#### Remarks

# Drawings and Specification - Numeral Correspondence

Fig.\_2

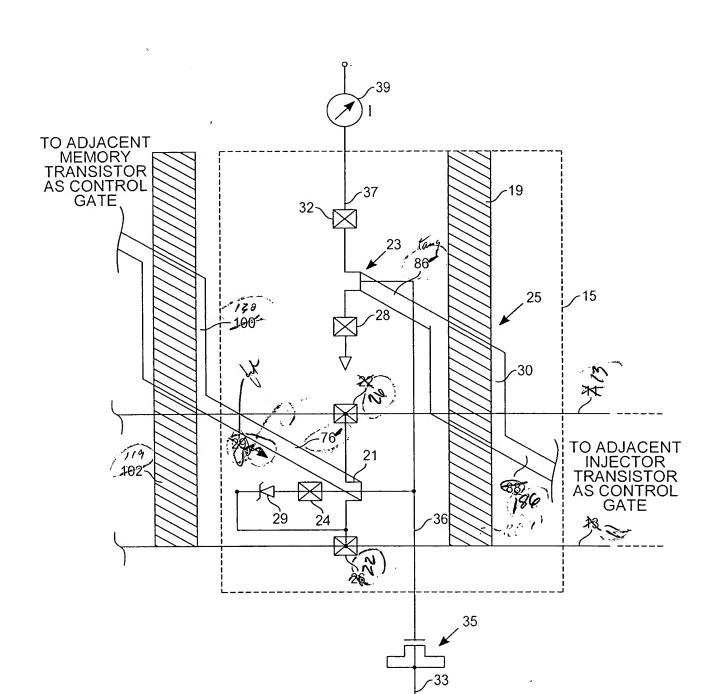
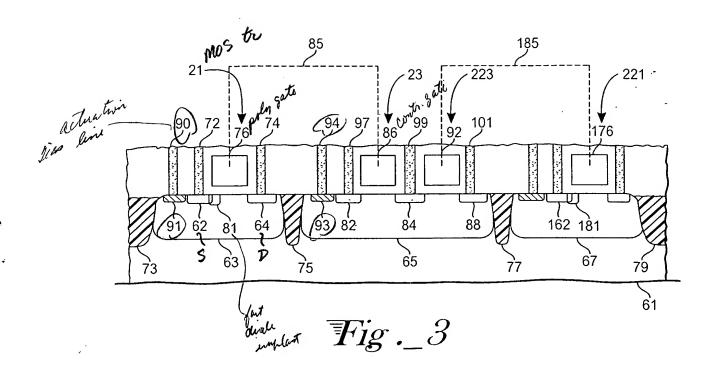
Reference character 28 is a cathode of diode 29 as noted by the Examiner and so page 9, line 8 has been amended to delete "28" as a contact and arrow 29 in Fig. 2 has been deleted.

In relation to Fig. 2, pages 6 and 7 of the specification (pages 4-5 herein) tang 76 has been changed to tang 76'. Plate "100" has been changed to - - 130 - - and word line "102" has been changed to - - 119 - - for consistency. Other tang membering has been changed or clarified in the same

paragraph so that the 3-dimensional tangs of Fig. 2 will relate to the 2-dimensional transistor elements shown in Figs. 3 and 4. The Examiner on page 5 of the Office letter points out certain informalities, namely that reference numeral "86" is described in different ways. To correct this, Applicant has amended the specification to call out reference numeral 86 as a "control poly gate" since it is both a control gate and a poly gate. In three dimensions, the gate extends from a poly plate as a tang, but the reference numeral has been changed to 86' when it appears as a tang, as mentioned above. This change has been made on the drawings as well as the specification. The same is true for tang 76'.

In Fig. 2, the orientation of the diode has been reversed by reversing contacts 22 and 26 and associated lines 11 and 13.

On page 6 of the Office letter, the Examiner is correct in assuming that transistor "31" should be - - 21 - -. Reference numeral "90" should be - - 76' - - in reference to a tang in Fig. 2. Both the drawing of Fig. 2 and the specification have been amended.

Fig.\_4

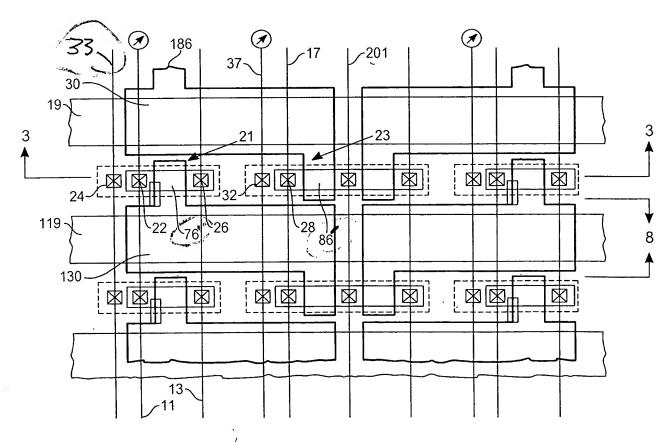
Claim 21 has been amended to recite that a single word line can select two transistors for simultaneous write and erase (using the tangs discussed above). For example, word line 119 in Fig. 4 supports this. On the other hand, Wong et al. require use of two different word lines for simultaneous write and erase. There is no anticipation because Wong et al. does not have a single word line for simultaneous write and erase in different cells.
